# RECORD OF DECISION

2350 Fifth Ave., New York (AKA, PS 141)  
State Superfund Project  
New York, New York County  
Site No. 231004  
March 2011

Prepared by  
Division of Environmental Remediation  
New York State Department of Environmental Conservation

FIGURE  
**3**

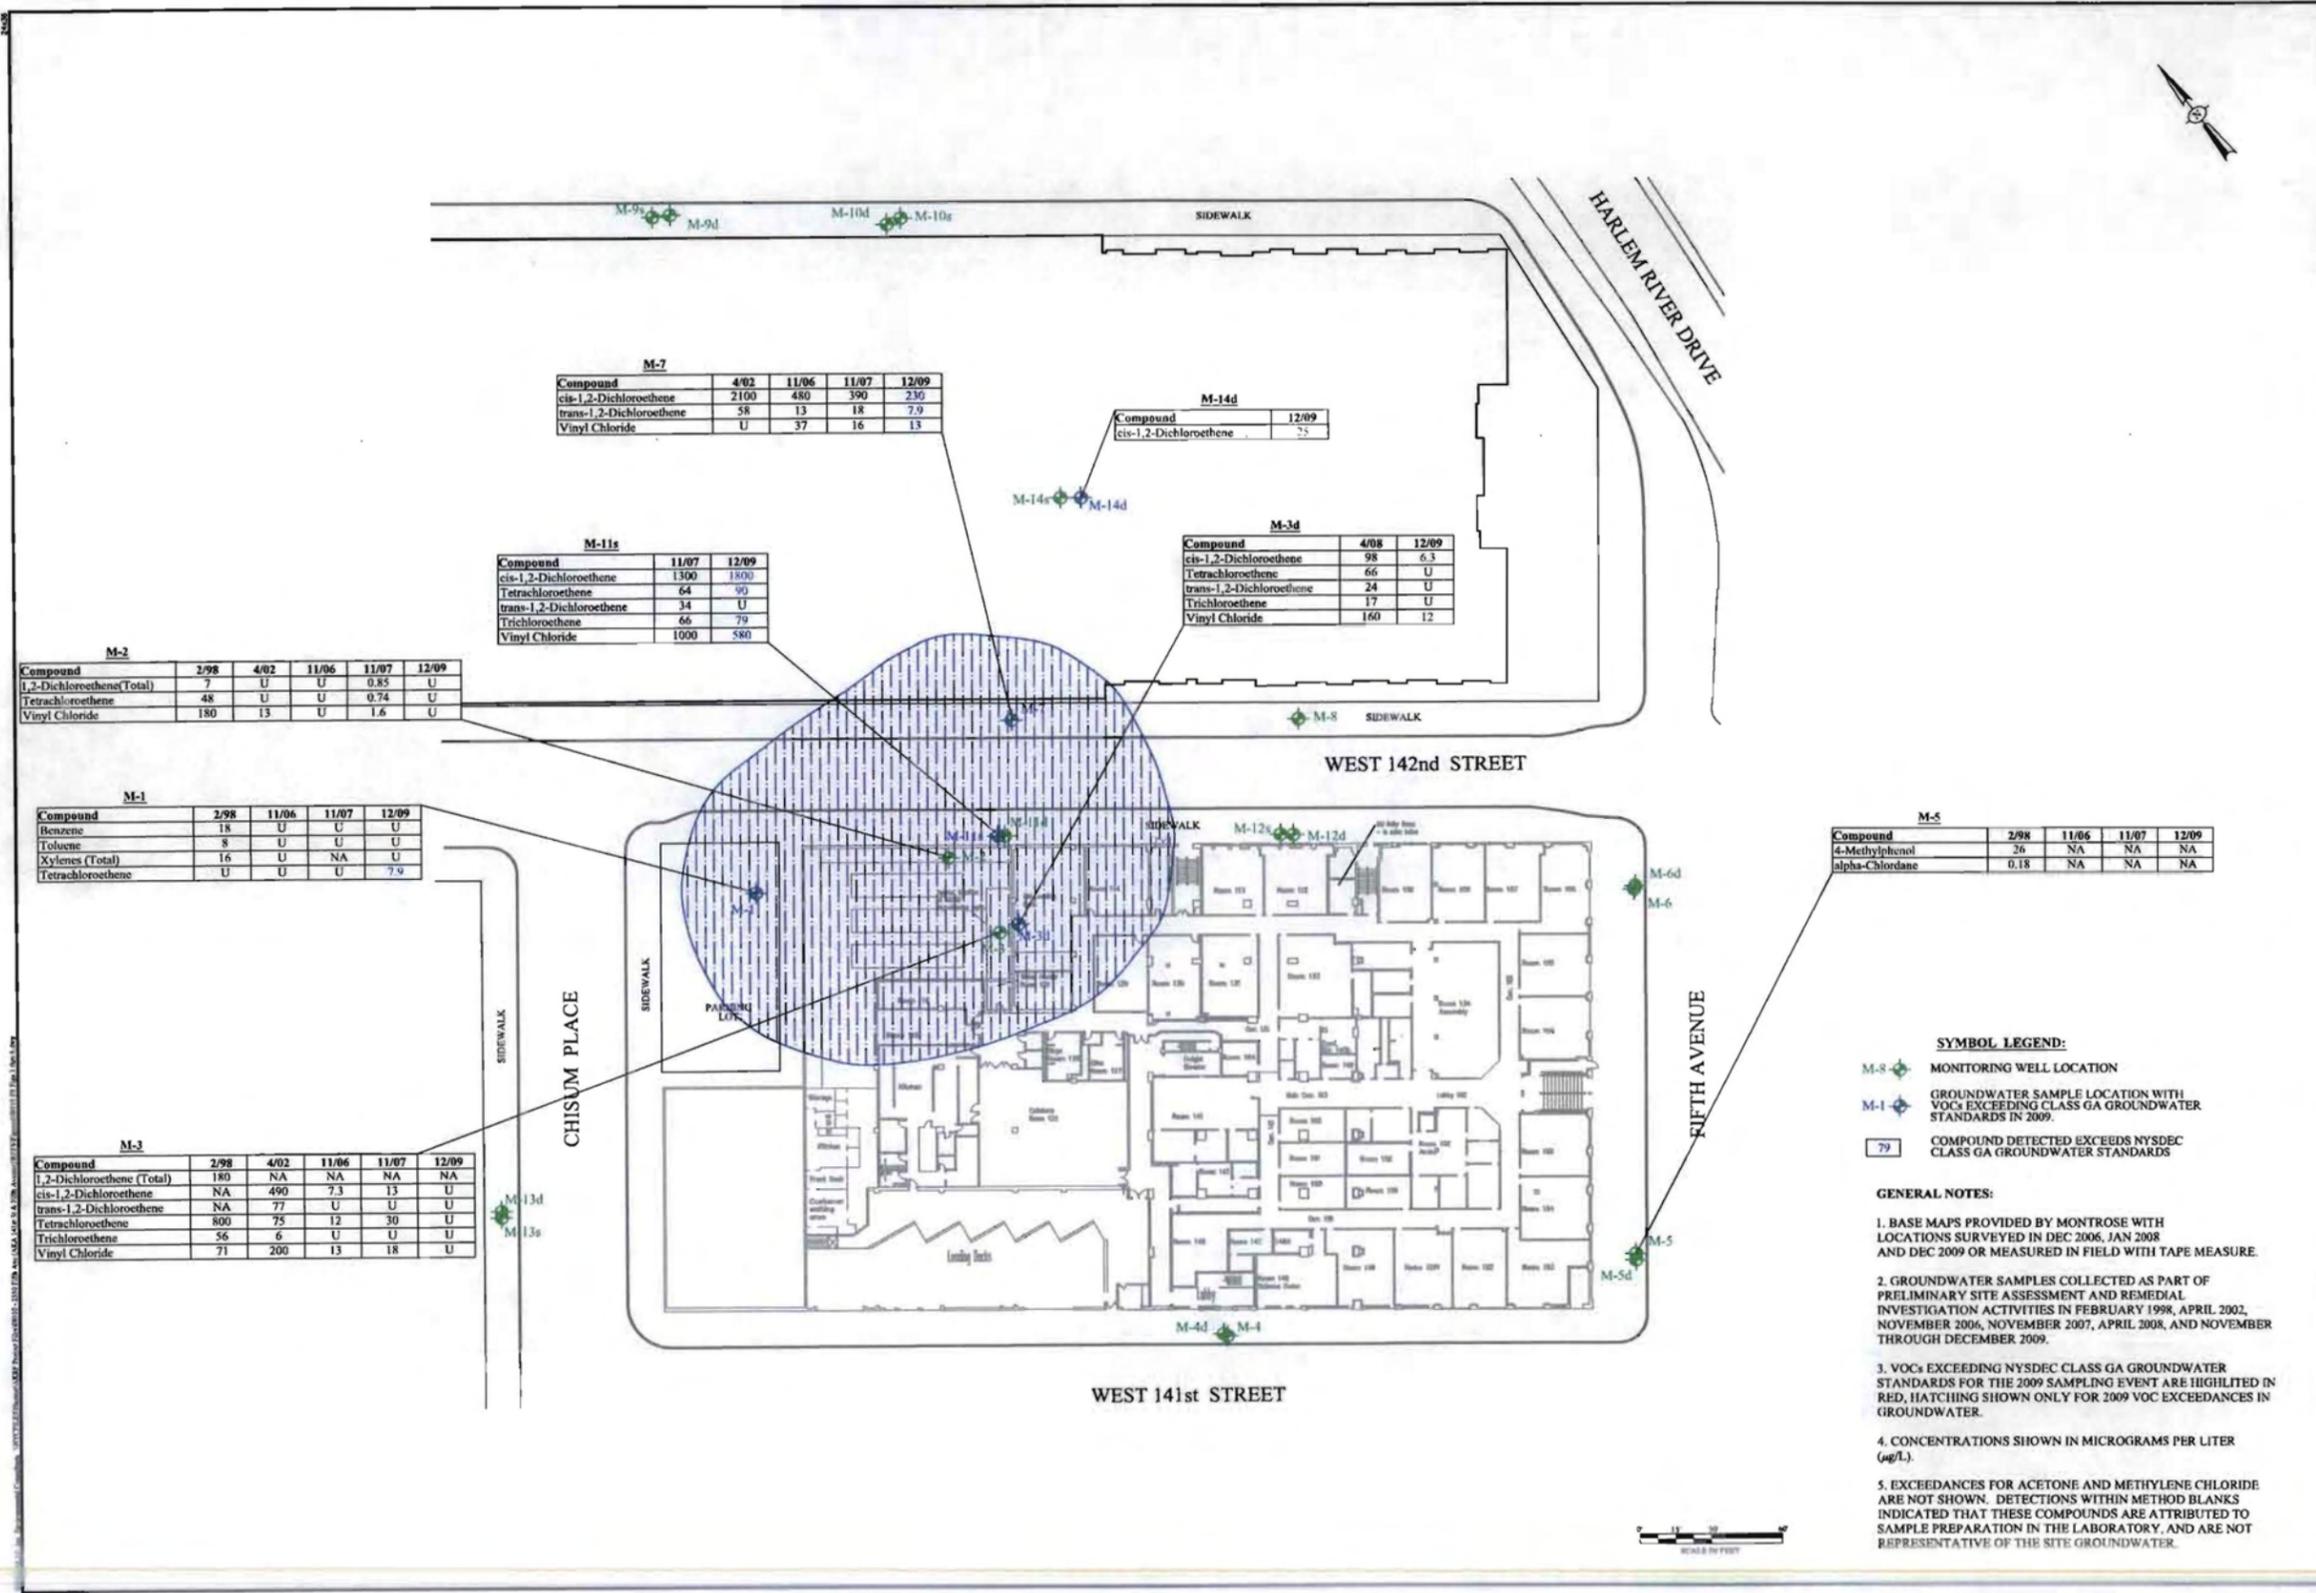
Groundwater samples were collected from shallow and deep monitoring wells beneath the structure located on the site, in the sidewalk around the site and beneath a structure on an off-site property (the Armory). As shown on Figure 3, PCE and its decomposition products were detected at levels that exceeded Class GA (Drinking Water) Ambient Water Quality Standards and Guidelines in 6 NYCRR Section 703.5 in samples from 7 of the 24 groundwater monitoring wells sampled from 1998 to 2009. Table 1 shown below includes all contaminants (volatile organic compounds [VOCs]) that exceed the drinking water SCGs for the 23 samples collected in the most recent (December 2009) sampling event.

**COMMENT 1:** *How will the groundwater contamination that extends under the sidewalk on the north side of 142<sup>nd</sup> Street be addressed to prevent it from migrating further off-site?*

**RESPONSE 1:** The proposed remedy includes in-situ groundwater treatment via direct injection of a product to promote reductive dechlorination in the source area. This treatment is expected to improve the quality of the groundwater leaving the site, thus preventing further off-site migration of contaminants.

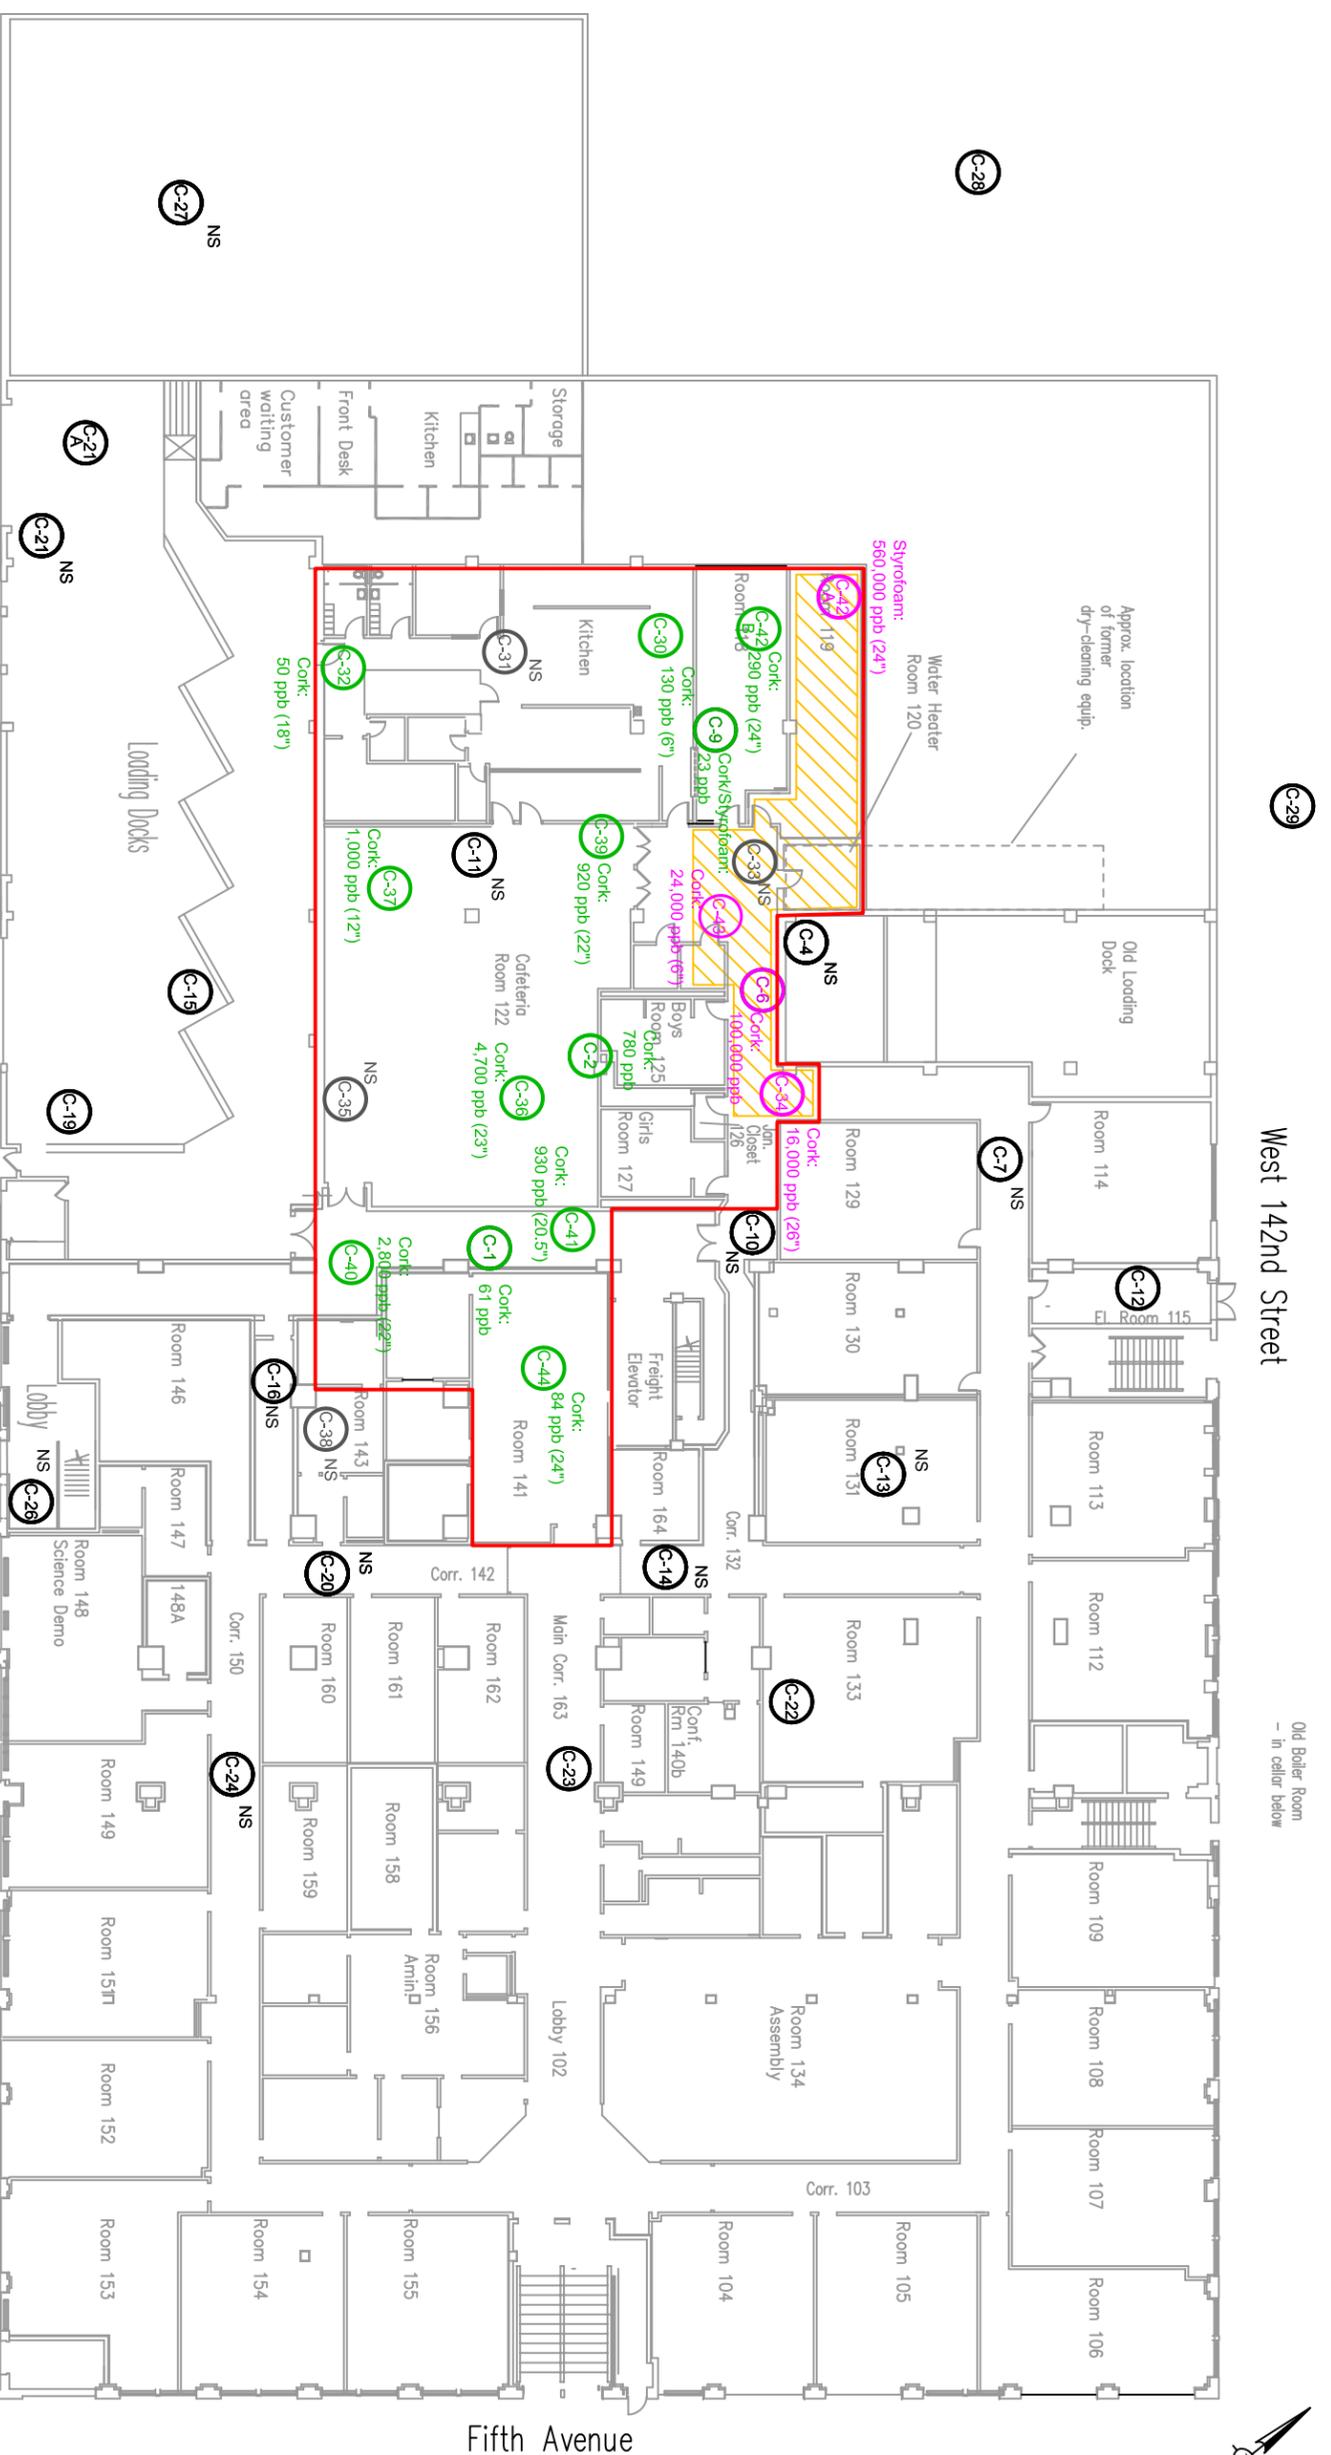
**COMMENT 21:** *However, it is noted that during the original investigation high solvent readings were detected in the air in the janitor's closet and 100,000 ppb Tetrachloroethylene was analyzed in the cork at 10" deep in boring C-6. To our knowledge this insulation under the Cafeteria and Kitchen of the School area has yet to be removed.*

**RESPONSE 21:** The insulation material at coring location C-6 is to be removed as part of the selected remedy, along with other areas where high concentrations of contaminants were identified in the insulating materials.
